File Number:	Roll Number:
Location of Property: <i>Iron Woods Drive</i>	
Owner (s) Name: <i>Douglas Mundell</i>	
Phone Number: [REDACTED]

Severed

LOT A

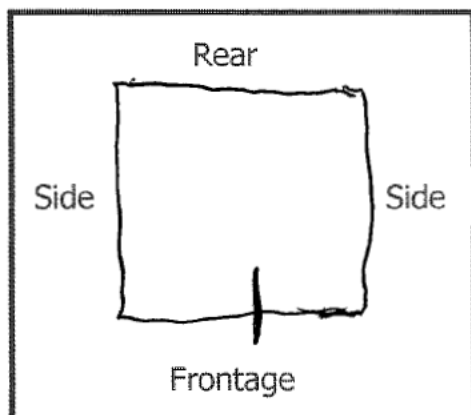
Street/Road Name:	<i>Iron Woods Drive</i>	
Safe Entrance Possible:	Yes ☒	No ☐
Culvert Required when lot developed:	Yes ☒	No ☐
3 metre strip of frontage from severed parcel required:	Yes ☒	No ☐
Other Requirements (i.e. fill, brushing, etc.): <i>existing culvert will need to be replaced, does not meet minimum length requirement of 9 meters</i>		
<i>Note - Culvert would need to be of equal or greater in diameter to handle water flow</i>

Retained (if vacant)

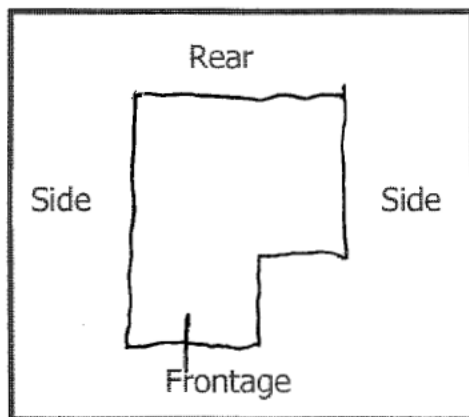
Street/Road Name:	<i>Iron woods Drive</i>	
Safe Entrance Possible:	Yes ☒	No ☐
Culvert Required when lot developed:	Yes ☒	No ☐
3 metre strip of frontage from severed parcel required:	Yes ☒	No ☐
Other Requirements (i.e. fill, brushing, etc.):

Additional Comments: *IF entrance to retained portion is to be off Iron Woods Dr a culvert of equal size to one at LOT A would be required. ATV Trail mentioned is accessed from LOT A entrance from what was observed.*
